**RE: U-Haul
8200 Jefferson Street NE
Conceptual Grading and Drainage Plans
Engineer's Stamp Date: No Stamp Date
Hydrology File: C17D146**

Thank you for taking the time to review the Conceptual Grading and Drainage plan for the proposed U-Haul development at 8200 Jefferson Street NE. We have received the city's review comments dated January 29, 2024 and have prepared the following information to address your review comments. Please note that for your convenience each review item is restated below along with our corresponding response.

ALBUQUERQUE NEW MEXICO
SITE ADDRESS:
U-Haul Moving & Storage
8200 JEFFERSON ST

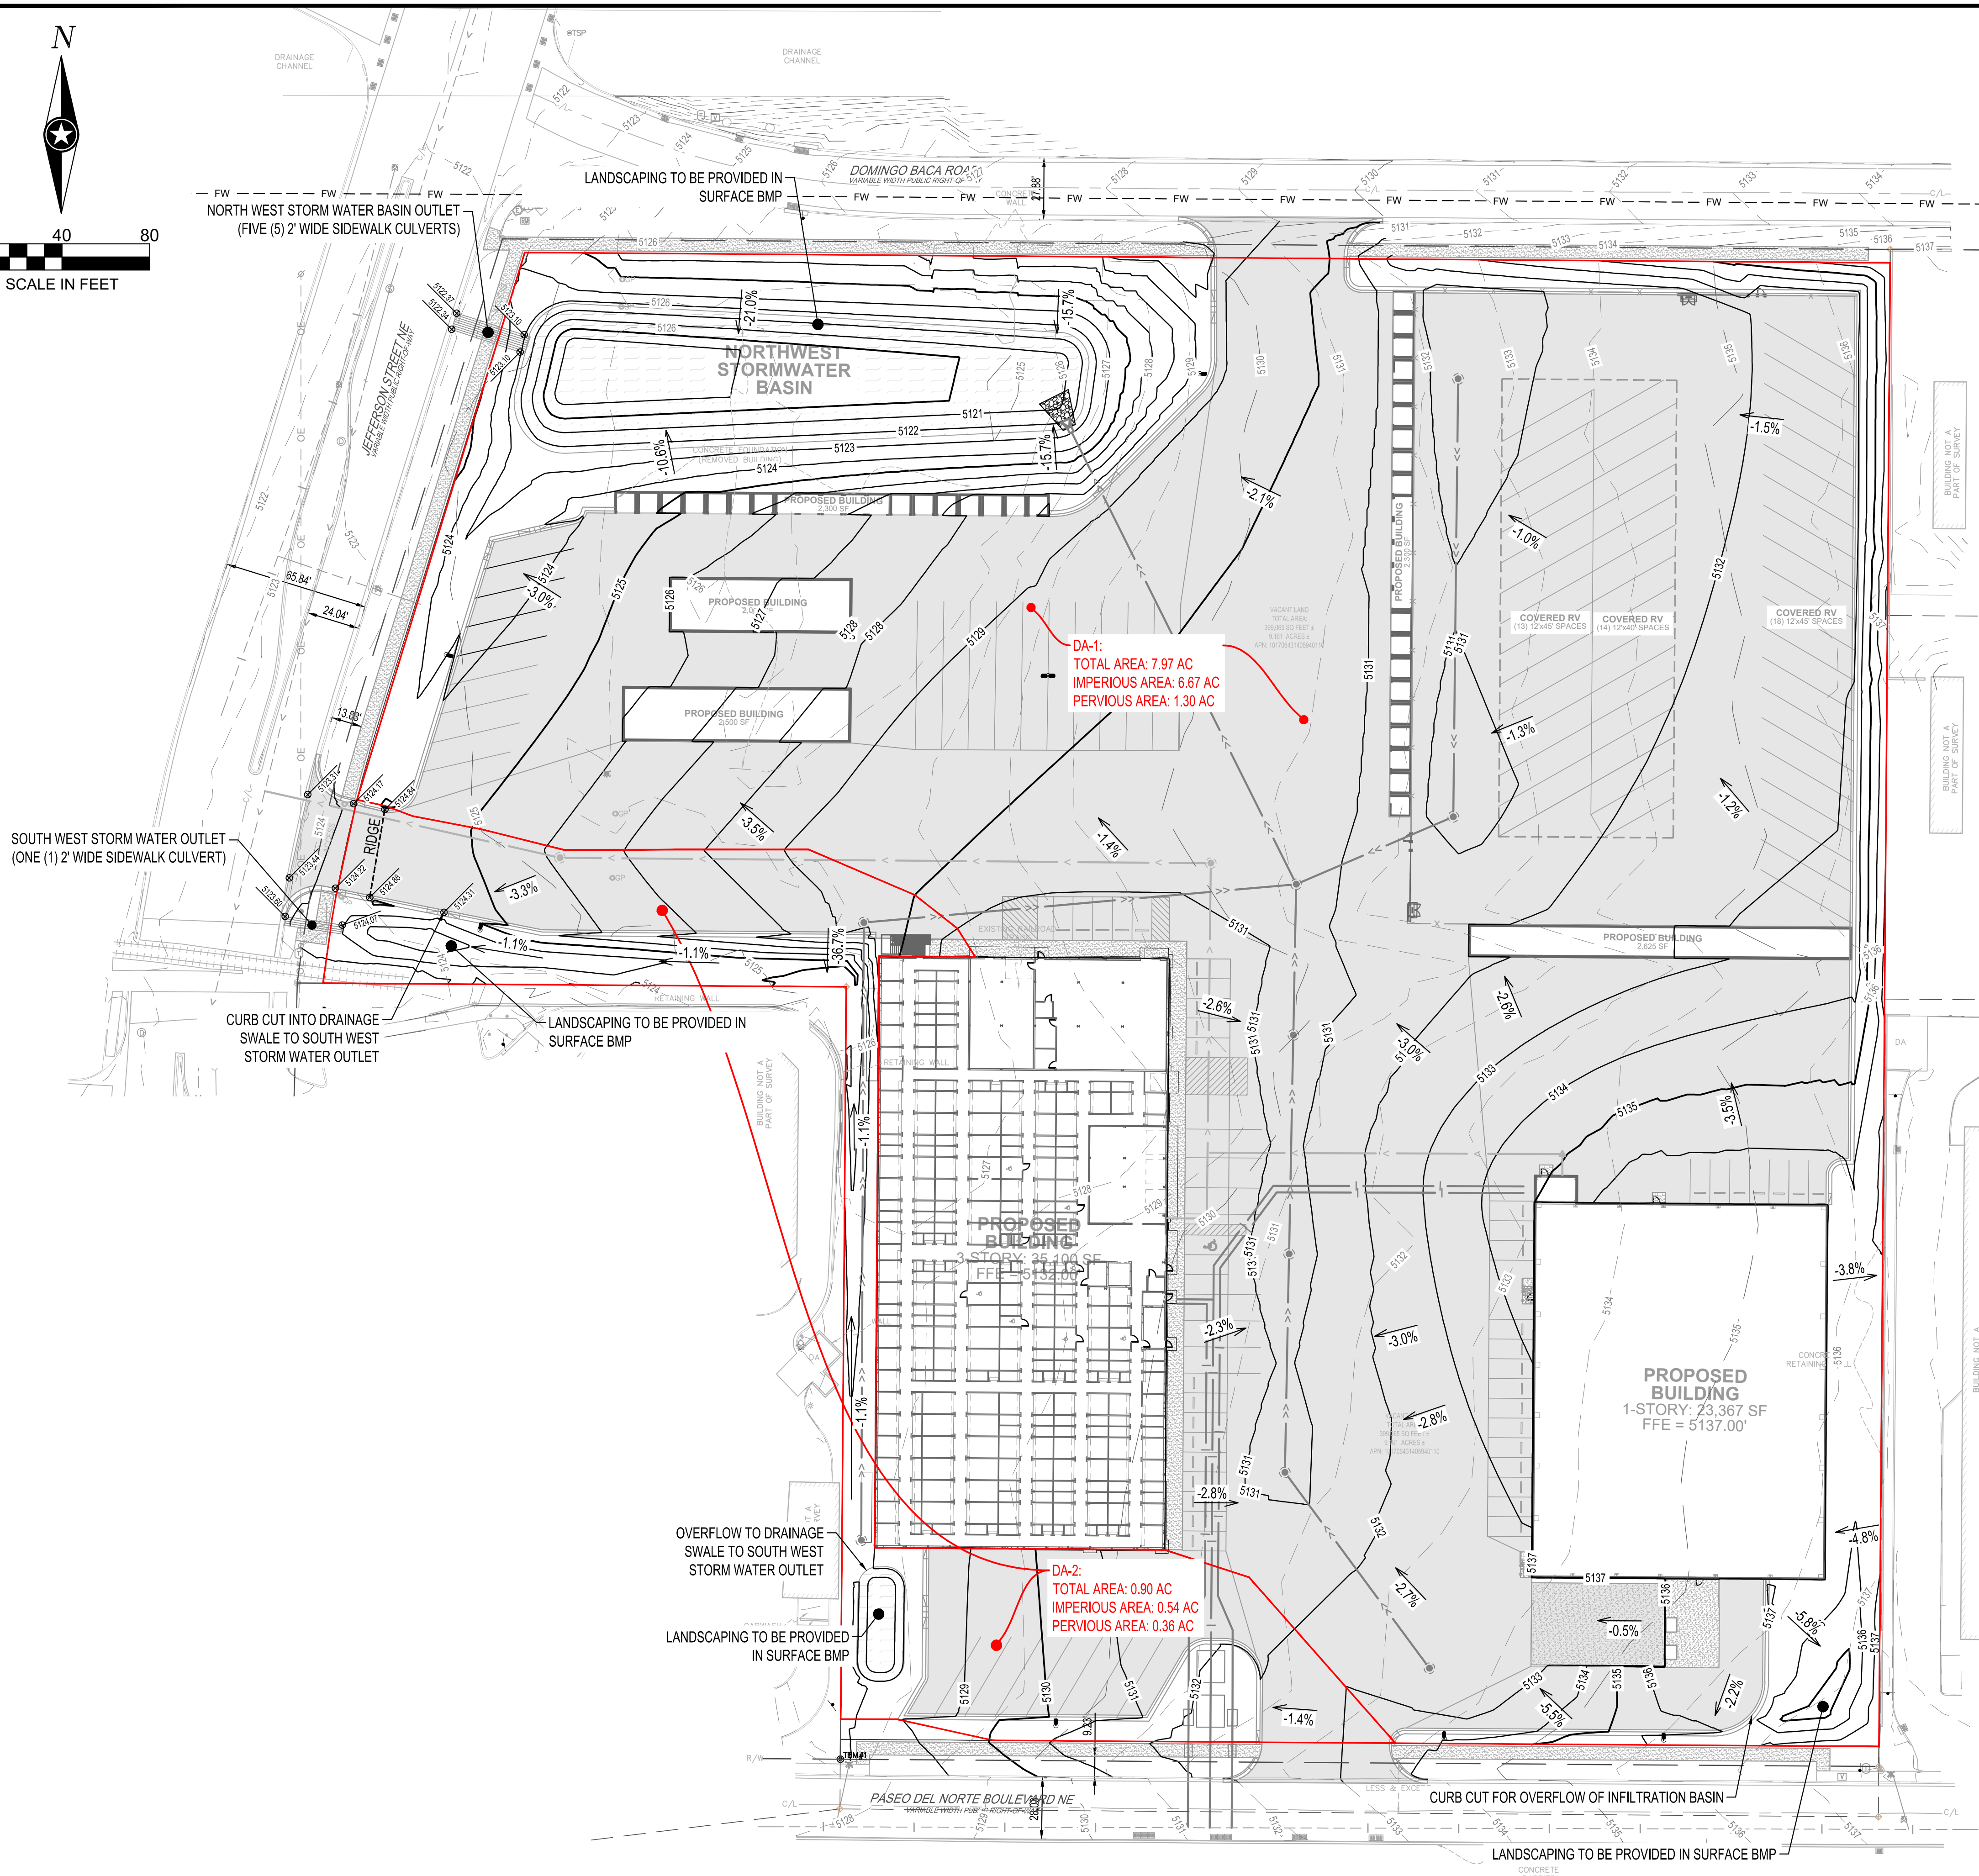
PO Box 1293
Based upon the information provided in your submittal received 05/14/2024, the Conceptual Grading & Drainage Plans are preliminary approved for action by the Development Facilitation Team (DFT) on Site Plan for Building Permit.

NM 87103
1. Please submit a more detailed Grading & Drainage Plan to Hydrology for review and approval. This digital (.pdf) is emailed to PLNDRS@cabq.gov along with the Drainage Transportation Information Sheet.
